Prairie Island Nuclear Generating Plant

Spent Fuel Pool Criticality Technical Specification Changes

Round 2 Request for Additional Information

Public Meeting
Rockville, MD
March 9, 2017

RAI-6 Preliminary Approach

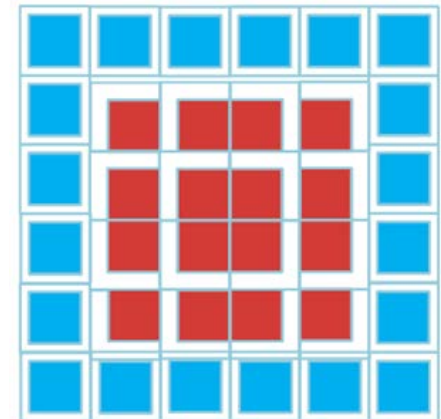
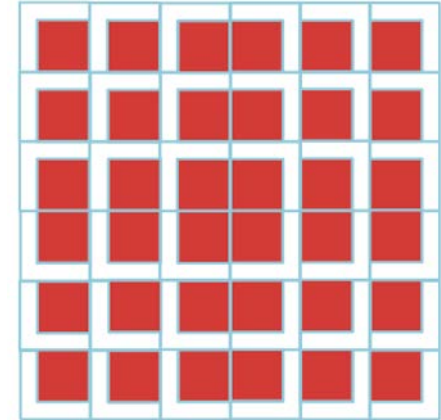
- Eccentricity modeled with some decoupling ($\Delta k \downarrow$)
- Eccentric effect applied as a bias
- Grid growth data taken from Westinghouse field data
- Selected bounding growth rate

- Assumes 4x4 (16) assemblies are adversely eccentric
 - ◆ Very improbable statistically (later)
- When reflected, two concentric rows decouple the eccentric array
- When reflected at boundary, the model represents >>16 eccentric bundles in SFP

Figure 7-4: Grid Growth Database Data for Longitudinally Stamped ZIRLO[®] Grids

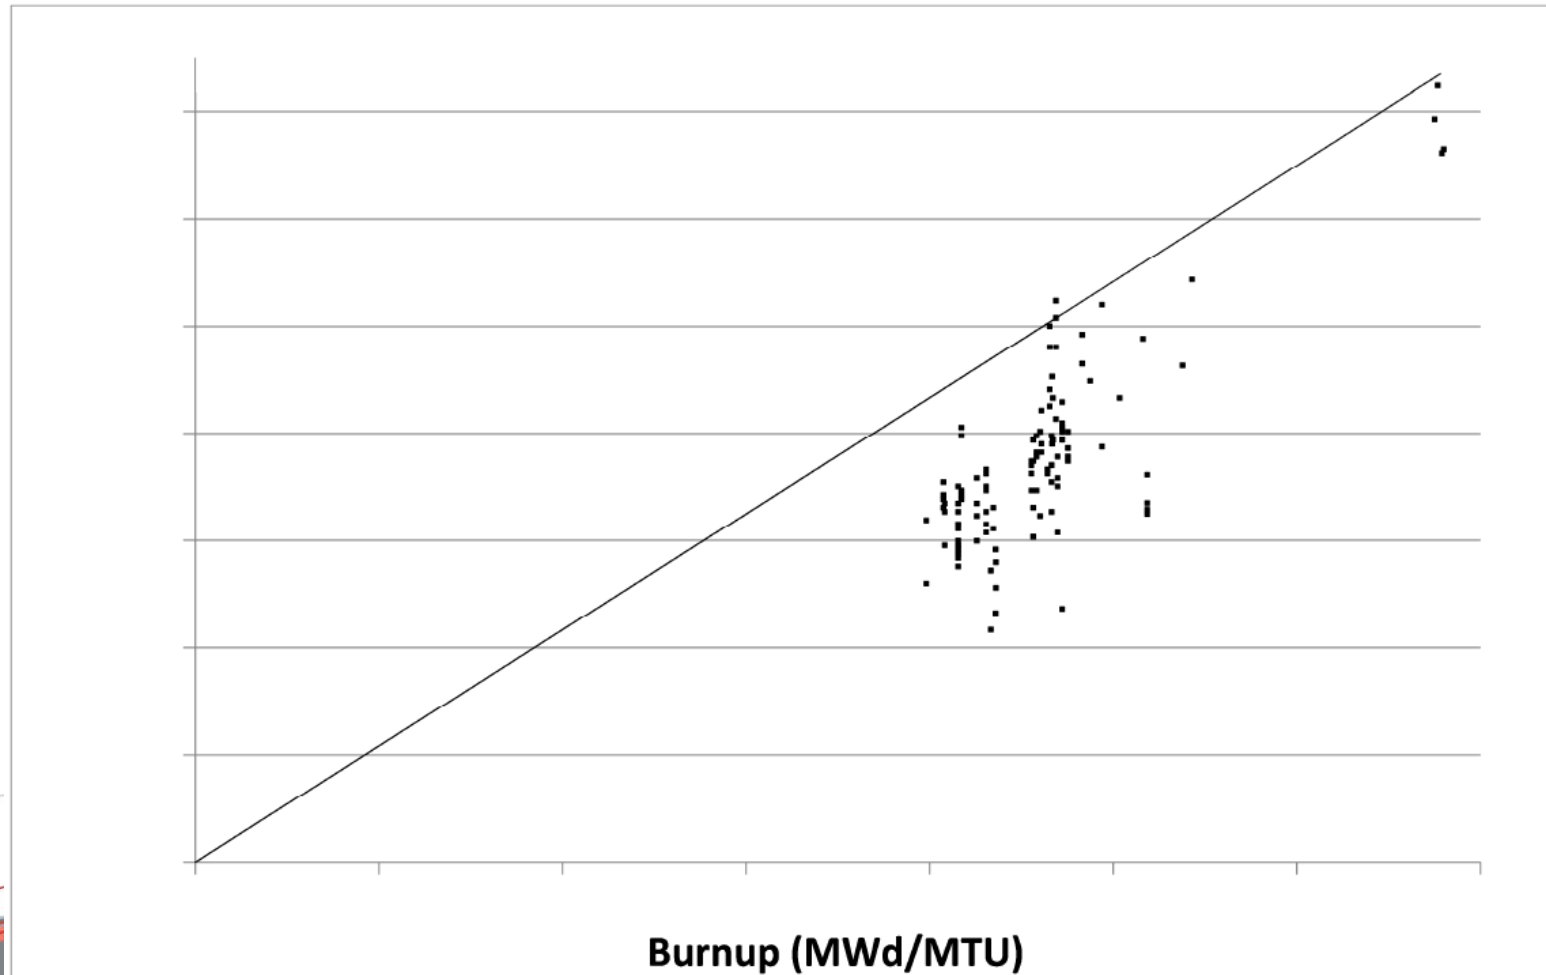
- Measured growth data from longitudinally stamped ZIRLO® grids
- 122 different measurements of growth at varying burnups
- Growth is scaled to 14x14 fuel grid size

- Excluded single data point, not median
- Assumed uniform pin pitch growth
- Assumed all grids grow at max growth rate
 - ◆ Ignores axial variation in burnup
 - ◆ Ignores Inconel top grid at location which drives reactivity most

RAI-6 Alternate Approach

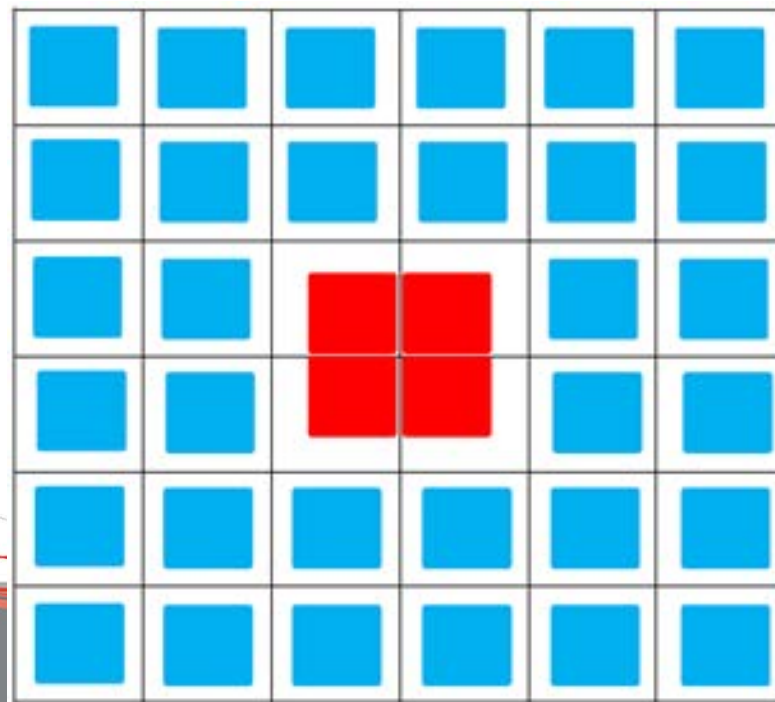
- Eccentricity traditionally handled as uncertainty
- PINGP fuel placement within a cell is a random, analog condition
 - ◆ Two-dimensional freedom
 - ◆ No forces to bias fuel in any particular direction
 - ◆ Imprecision of fuel placement equipment
 - ◆ Imprecision of fuel placement process
 - ◆ Success criterion: anywhere within storage cell

Figure 7-4: Grid Growth Database Data for Longitudinally Stamped ZIRLO® Grids

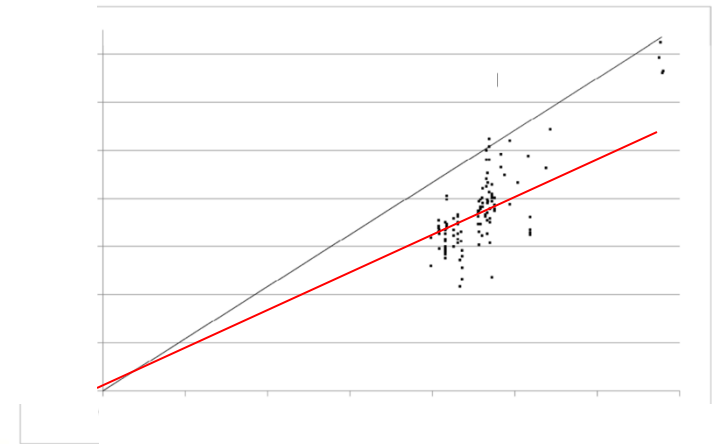
- **Grid growth not previously considered**
- **No topical treatment of data**
- **In recognition of the stated conservatisms:**
 - ◆ Use the median growth value, and
 - ◆ Credit non-uniform growth distribution
